MANUFACTURERS' RECEIVER TROUBLE CURES

VOLUME 7

(CAT. NO. 143-7)

Fig. 4 — Hoffman

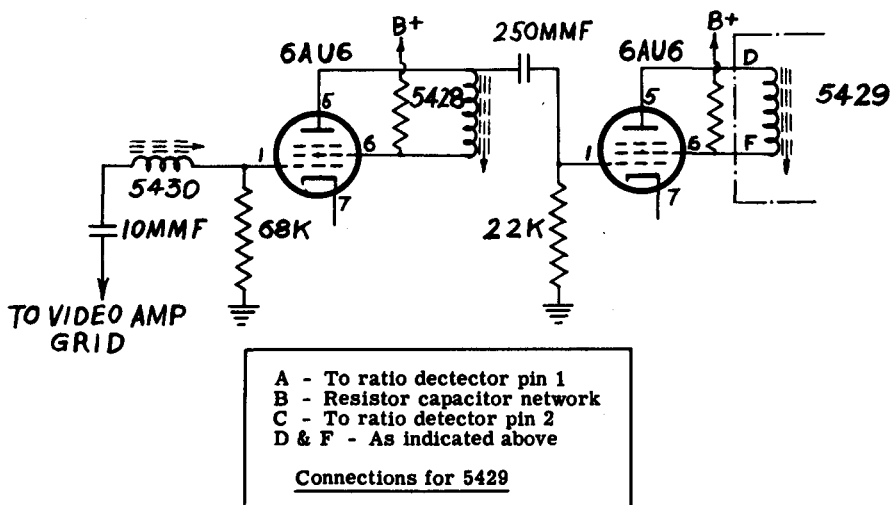
Preventing excessive loading on horizontal output transformer.

R719, the 100k-ohm, 1-watt resistor that is shunted across lugs 1

and 2 of L703 (horizontal yoke winding) is deleted from the above chassis. The change results in a slight increase in high voltage and horizontal width. It is suggested that the change be made on service call as preventative maintenance since should R719 decrease appreciably in value over a period of time, the result would be excessive loading on the horizontal output transformer, causing low horizontal sweep, low high voltage, and low agc keyer pulse. In some instances, the lowering in keyer pulse has been responsible for sync clipping because the agc bias became too low in a strong signal area.

Fig. 5 — Hoffmann

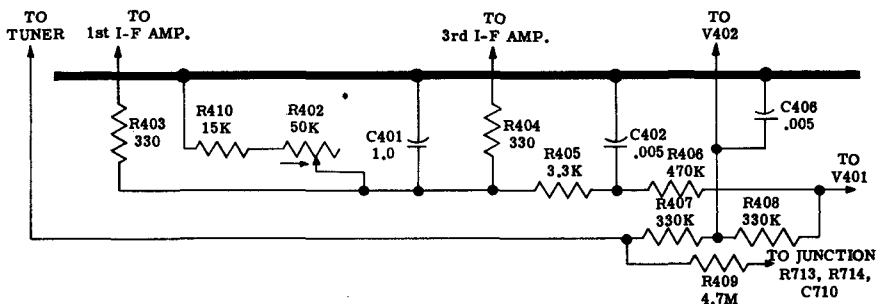
above series receivers. The new control is located on the chassis rear apron next to the Horizontal Frequency knob. The figure shows the new agc circuit. A comparison of this circuit with the original schematic diagram will disclose that R402, the 47k-ohm resistor that forms a portion of the agc voltage divider, has been replaced by a 50k-ohm potentiometer connected as a rheostat and a 15k-ohm fixed resistor. This circuit arrangement places the position of the tap on the i-f agc voltage divider at the discretion of the serviceman. In order to maintain the crossover point of the r-f and i-f agc voltage where it was prior to the above change, it is necessary to increase R407, the 180k-ohm resistor, to 330k ohms in the delayed agc network.

When the agc control is turned fully clockwise, the greatest bias appears on the i-f agc bus and the lowest

bias appears on the r-f agc bus for a given signal. When the control is turned fully counterclockwise, the situation is reversed; the i-f agc bias voltage is minimum and the r-f agc bias is maximum for a given signal. This source of high r-f bias is very useful when strong signals cause the video stages to overload, clipping the sync pulses.

Fig. 6 — Hoffman

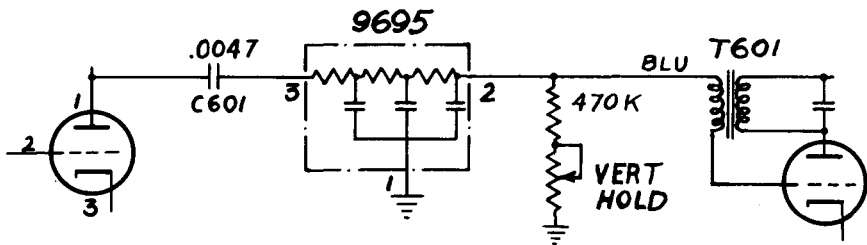
Picture shift at maximum contrast.

Some of the receivers listed above have had a slight horizontal shift when maximum contrast was used. This condition can be remedied by increasing the value of R304, 47-ohm, 1/2-watt, 20% resistor (connected between the low side of the contrast control and ground) to a 150-ohm, 1/2-watt, 20% resistor. When this is done, a connection should be run from the top, *not ground*, of this 150-ohm resistor to the Fringe position of the Maximum Performing selector switch on the rear of the set, so that when in a Fringe position, maximum contrast can still be obtained.

Fig. 9 — Magnavox

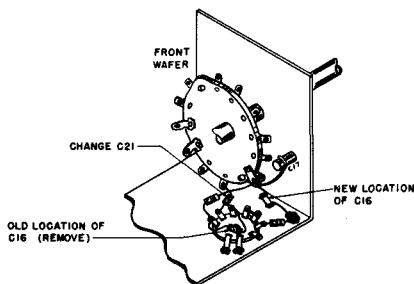
MAGNAVOX Chassis 103-series
Correcting sound drift
 (see Fig. 9).

1. Replace *C21*, 10- μ mf capacitor (black, brown, black, black, white) with 10- μ mf, N750 capacitor (violet, brown, black, black, white), part No. 250088G63. *C21* is the capacitor connected to the front lug at the base of the front wafer.

2. Remove *C16*, 3- μ mf N750 capacitor (violet, black, orange, black) from oscillator socket.

3. Add 3- μ mf, N1800 capacitor (orange, orange, black, orange, black, green), part No. 250088G57, from rear lug at bottom of front wafer (connection point for *C17* oscillator trimmer) to chassis ground in front of oscillator socket (connection point for *C22*). Keep leads as short as possible.

Fig. 10 — Magnavox

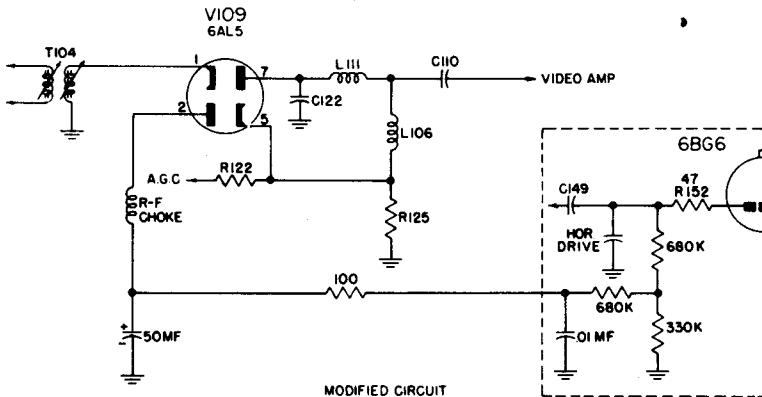
MAGNAVOX Chassis 104-series
Removing adjacent channel interference.

To remove adjacent channel interference where necessary, install trap No. 360457-1 from 1st i-f plate to ground and tune to 27.25 mc.

For rejection of a 19.75-mc signal, connect trap to the plate of the 2nd i-f amplifier.

Fig. 13 — Magnavox

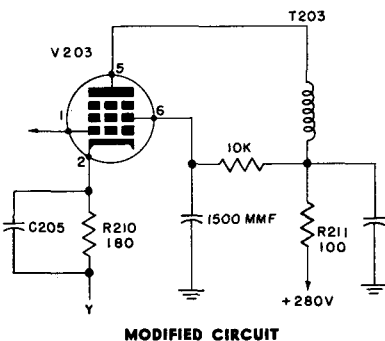
If signal blocks when tuning from weak to strong signals, proceed as follows:

3. Blocking may be due to excessive grid current in *V203*, the 3rd video i-f amplifier. This circuit may be modified as shown in the illustration.

Fig. 14 — Magnavox

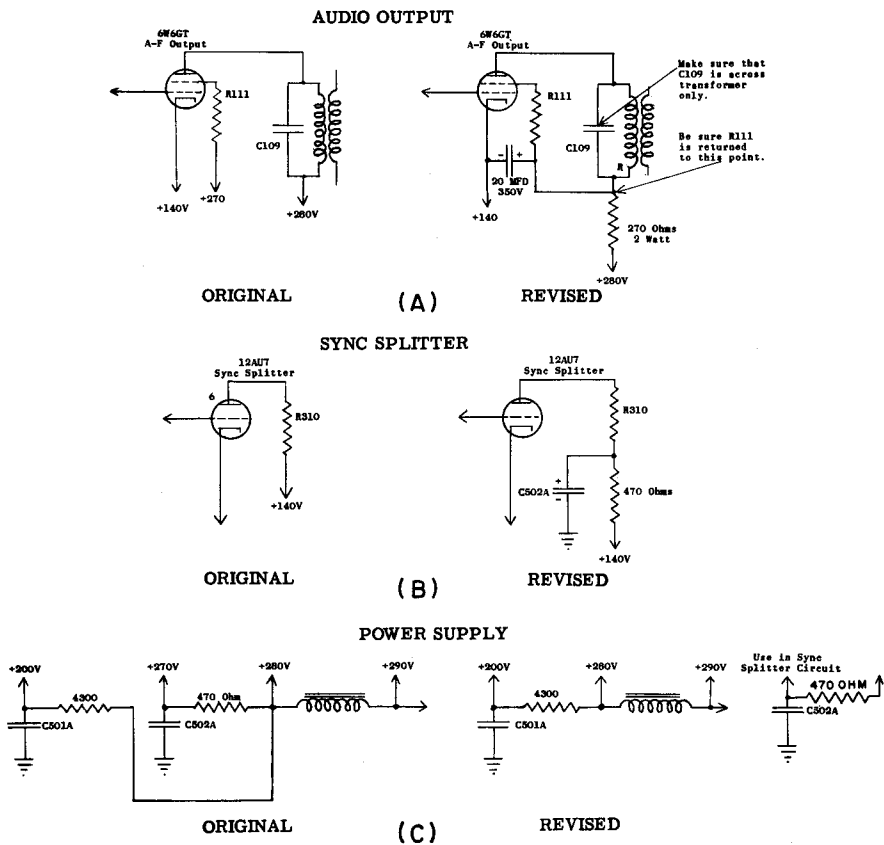
MAGNAVOX Chassis 108-series Reducing hum and buzz (see Fig. 14).

The schematic diagrams shown here illustrate the circuit revisions used for reducing hum and buzz in the above series chassis when necessary. Notes on the schematic diagrams indicate important points to check when making these changes to insure proper operation.

The changes involve the addition of decoupling filters in the audio output and sync splitter stages. Note that the components required for the sync splitter may be obtained from the power supply circuit.

Fig. 16 — Majestic

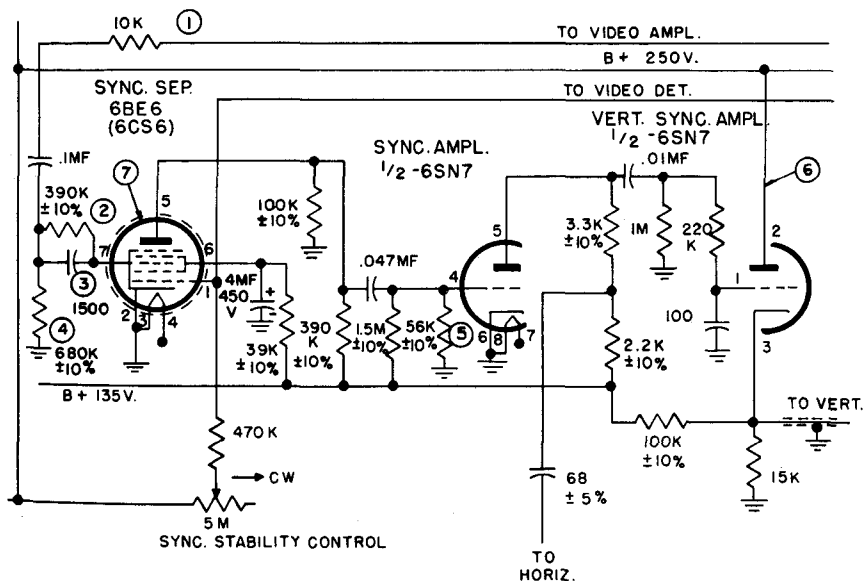
The following changes, already made in later production of the above chassis (coded with suffix letter *A* following chassis series code) are incorporated in order to provide improved sync stability. These changes also allow the Sync Stability control to be further advanced for noise immunity in high signal areas.

1. Add 10k-ohm, $\pm 20\%$, $\frac{1}{2}$ -watt resistor in series with sync input lead.

2. Add 390k-ohm, $\pm 10\%$, $\frac{1}{2}$ -watt resistor in series with sync separator control grid.

3. Add 1,500 μmf , $\pm 20\%$, ceramic capacitor in series with sync separator control grid.

4. Change sync separator grid resistor from 470k ohms to 680k ohms, $\pm 10\%$, $\frac{1}{2}$ watt.

5. Add 56k-ohm, $\pm 10\%$, $\frac{1}{2}$ -watt resistor from pin 4 of sync amplifier 6SN7 to ground.

6. Remove 33k-ohm plate resistor of vertical sync amplifier and connect plate (pin 2) to 250-volt B+ instead of 135-volt B+.

The schematic diagram shows the revised sync amplifier circuits, with the circled numbers corresponding with the numbered steps above.

Fig. 17 — Mars

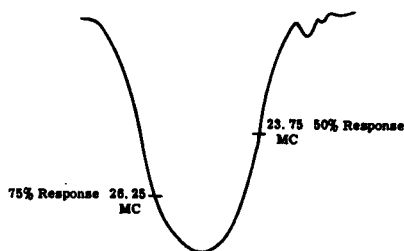
MARS TV Model 630-K3B
Extreme fringe area alignment
(see Fig. 17).

For extremely difficult fringe area coverage where signal-to-noise ratio is a problem, it is possible to narrow the 4-mc i-f bandwidth to 2 1/2 mc to obtain extra gain and a better signal-to-noise ratio. It has been found that in the nominal 100 to 150 mile sector where video reception is possible but not comfortably viewable, the 2 1/2-mc bandwidth will in most cases bring in the picture to a suitable viewable point, minimizing snow.

Make sure to readjust all the traps to their proper frequencies (as listed on the schematic circuit diagram) before and after spot alignment. Then remove the signal generator and con-

nect a sweep generator to the antenna input at any one of the low frequency channels and touch up the i-f coils for the response indicated in the illustration, making sure that the 26.25-mc point and the 23.75-mc point are adjusted as indicated on the curve. Should any of the i-f's require more than a touch-up, the trap associated with that stage must be retuned. It is usually a good procedure to recheck all the traps after sweep alignment.

Fig. 19 — Motorola

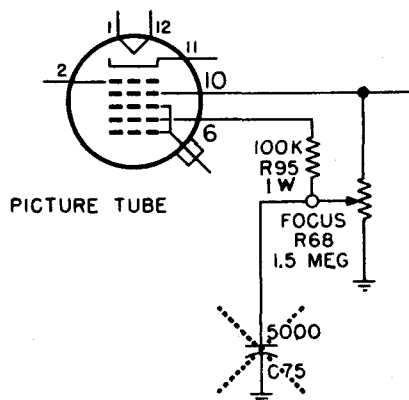
Providing added protection to focus control (see Fig. 19).

To add protection to the focus control potentiometer, the following changes, already made in later production are included:

1. C75, 5,000- μ mf capacitor is removed.
2. R95, a 100k-ohm, 1-watt resistor, is added between the focus control arm and the blue lead to the picture tube focus anode. (Note: The

pin 2 plate of 1st sync clipper) is changed to 1 meg.

CIRCUIT CHANGES, D-201 CHASSIS, FOR INCREASED LIFE OF 12B4 TUBE

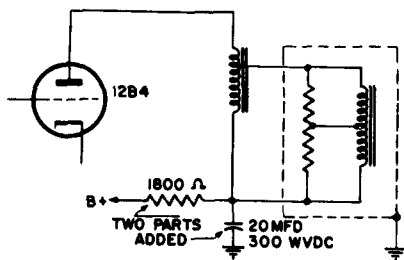
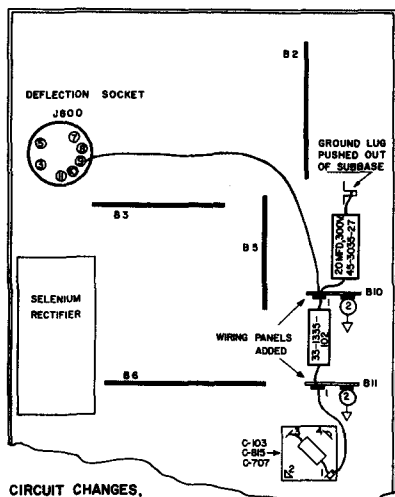
1. Mount two 2-lug wiring panels in the locations shown on the accompanying layout drawing. These panels will be referred to as *B10* and *B11*.

Fig. 34 — Philco

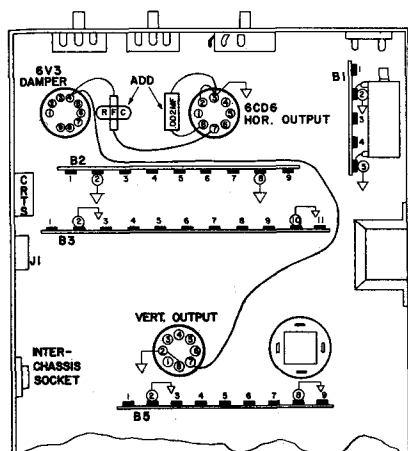
1. Add a .002- μ f, 400-volt capacitor (part No. 30-1238-8 or 30-4650-

37) between pin 3 and pin 8 of the 6CD6G horizontal output tube. Schematically this capacitor is added from screen grid to cathode of the 6CD6G tube.

Fig. 35 — Philco

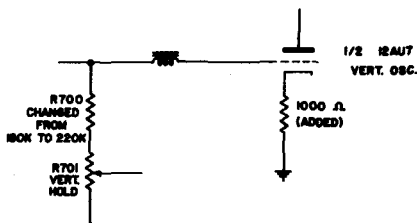
Note: These changes are already made in later production run 4 for

chassis J-2 and in later production run 3 for Chassis J-5.

Fig. 36 — Philco

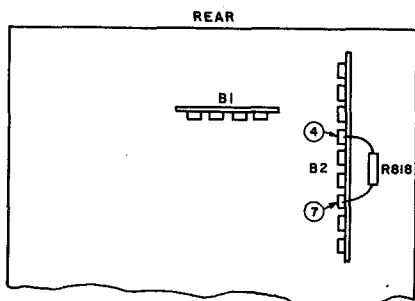
1. Resistor *R818*, 22k-ohm, 2-watt

resistor connected between lugs 4 and 7 on terminal board *B2*, is changed to a 33k-ohm resistor.

Fig. 37 — Philco

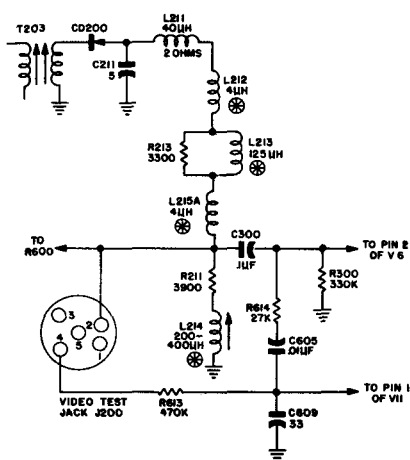
To reduce channel 5 picture beat, an additional 4- μ h series peak-

ing coil (*L215A*, part No. 324112-50) is added to the video detector load circuit. To install this coil, terminal board *B9* adjacent to the video test jack is changed from a 2-lug to a 3-lug type. The revised wiring of the video detector circuit, already done in later production run 18, is shown in the figure.

Fig. 38 — Philco

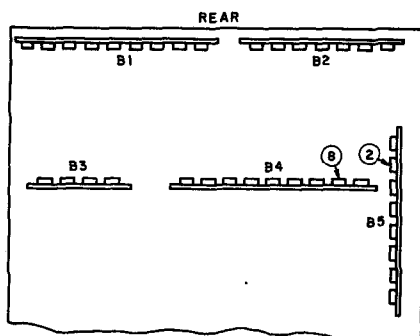
PHILCO R-f chassis R-191 **Improving video transient response (see Fig. 38).**

To improve video transient response, all wiring is interchanged between lug 8 of terminal board *B4* and lug 2 of terminal board *B5*. A bottom view of the chassis showing these

boards is shown in the figure. This change is already made in later production run 3.

Fig. 39 — Philco

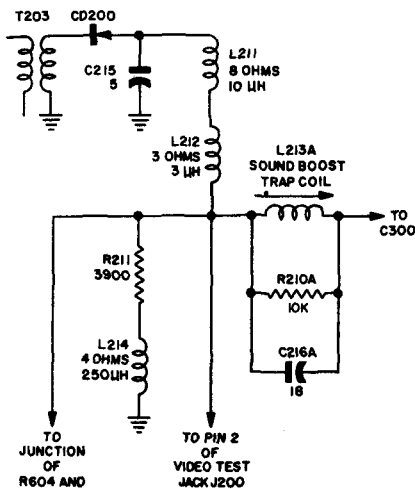
1. *L213* and *R210* are replaced by a 4.5-mc sound boost trap coil in the

video detector circuit (new part No. 32-4463-7).

Fig. 41 — Philco

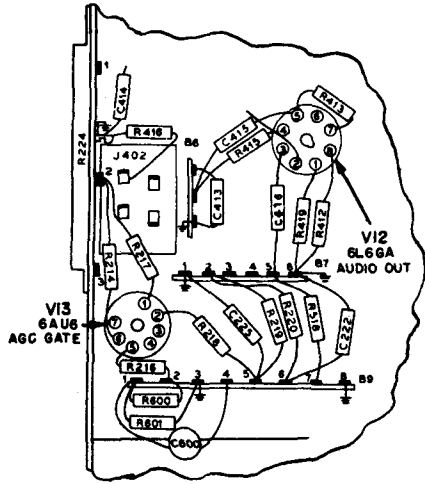
To permit use of the uhf tuner with the above chassis, the following changes, already included in later production are made:

1. Lead of resistor *R518*, 15k ohms, is moved from lug 5 to lug 4 of terminal board *B7*.
